Annual Monitoring Report

Monitoring Year 7 of 7

North Fork Mountain Creek Stream and Wetland Restoration Site

RE: North Fork Mountain Creek Stream and Wetland Restoration Site: MY7 Monitoring Report (NCDMS ID 94151)

Exhibit A

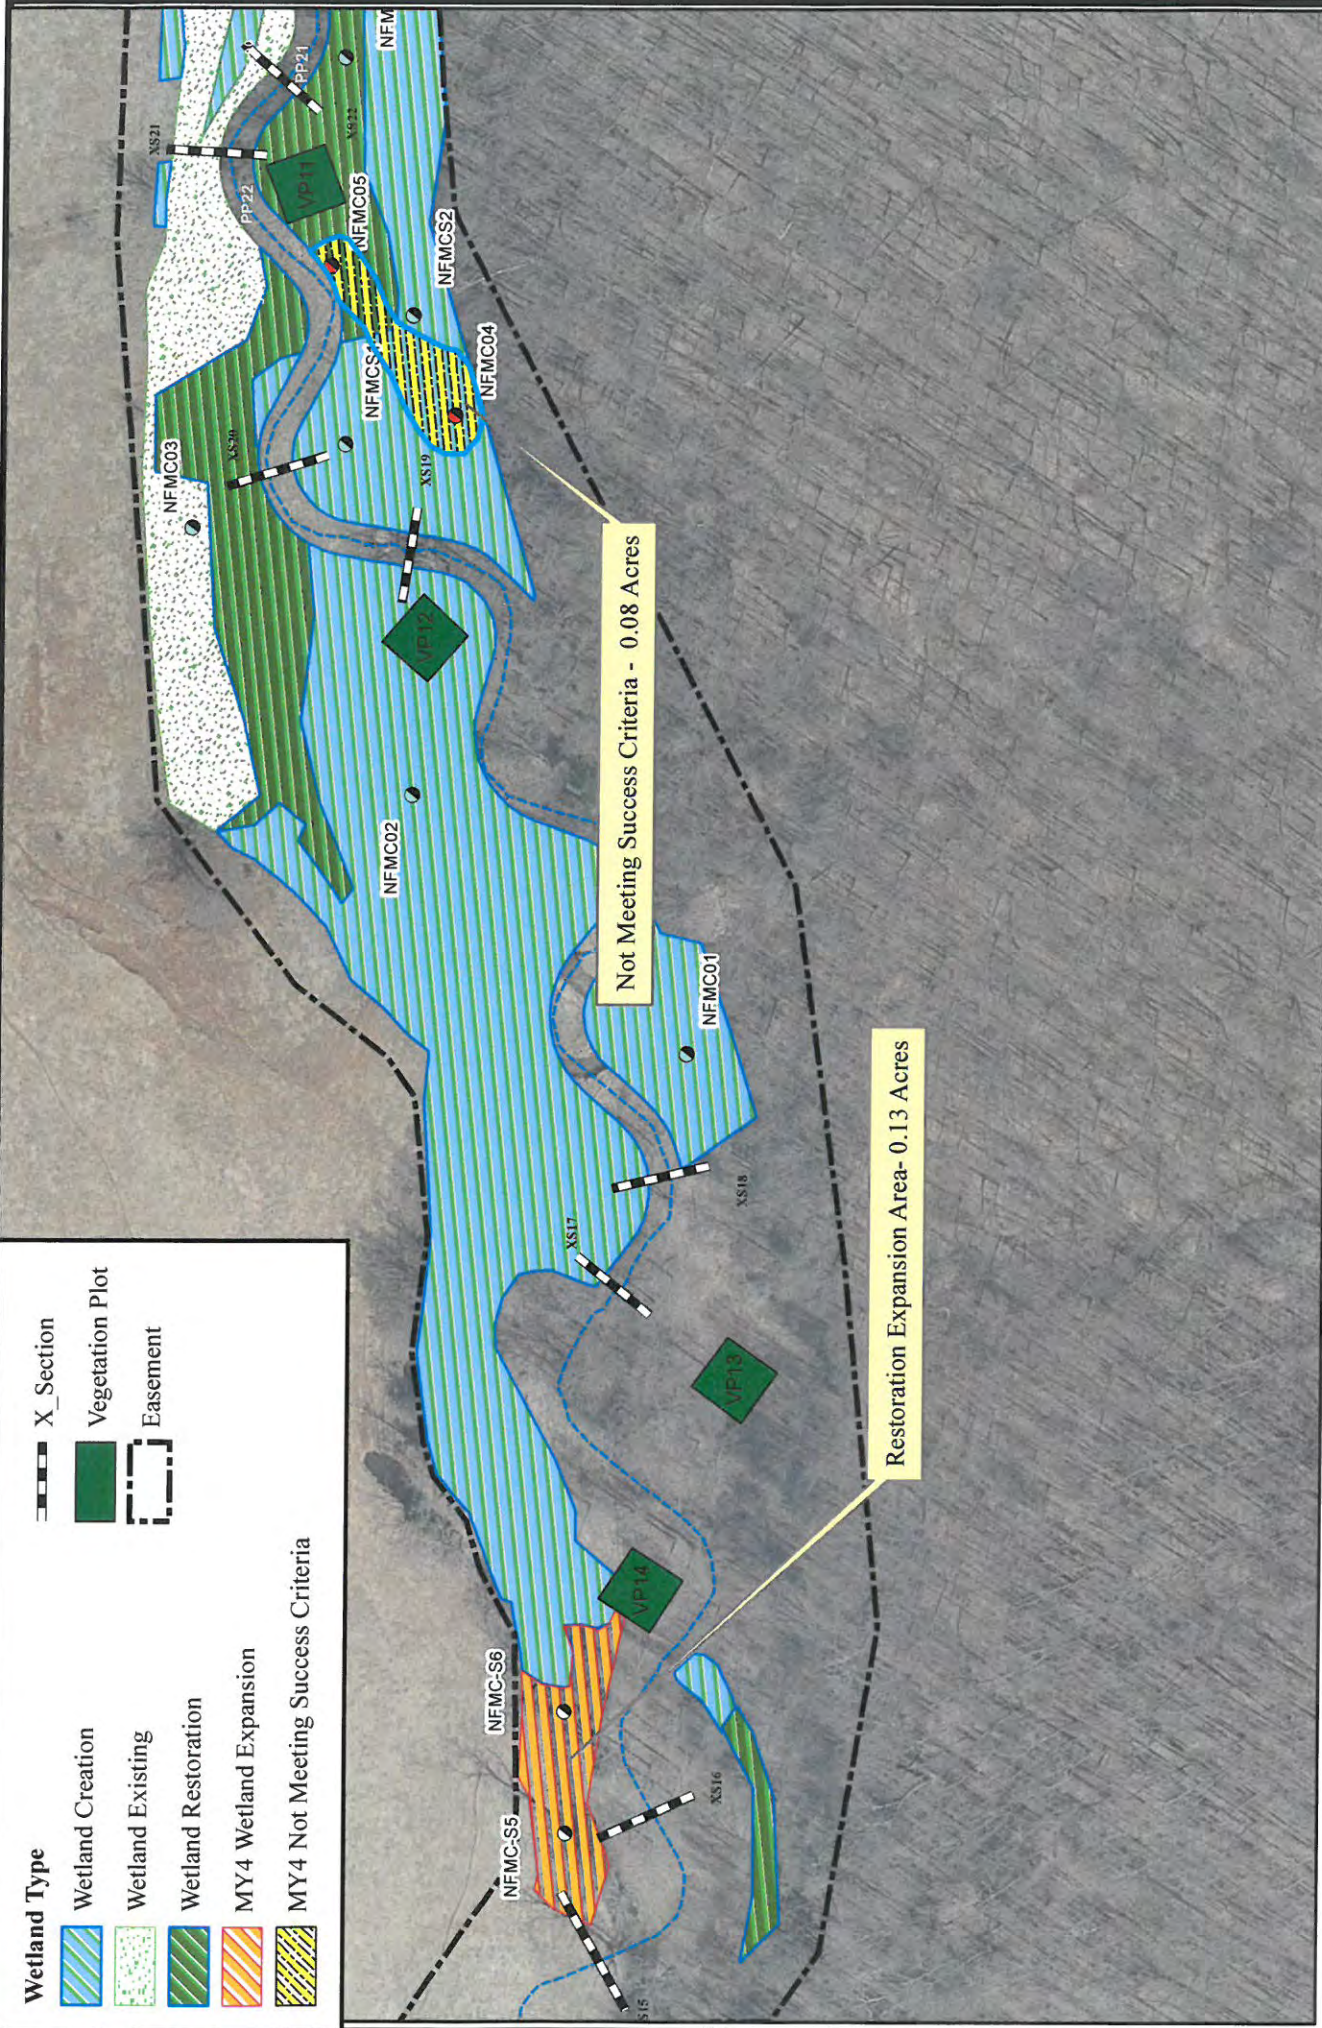
An additional wetland area that was not initially accounted for in the Restoration Plan is being proposed to offset the areas around monitoring wells NFMC04 and NFMC05 (data will continue to be collected from the non-performing areas). This additional area of wetlands has been delineated and additional groundwater monitoring wells were installed February 19th, 2015. (Exhibit A) The additional delineated wetland area will offset the non-performing areas, see wetland data forms (Exhibit B).

North Fork Mountain Creek Stream (DOMS project) NC DWR approves the modification request for the additional wetland area which will offset the wetland area around wells NFMC04 and NFMC05 that are not meeting the 8% hydroperiod success criteria. The 8% success criteria for the new wells installed February 19th, 2015 should be met for the remainder of the project during normal precipitation years.
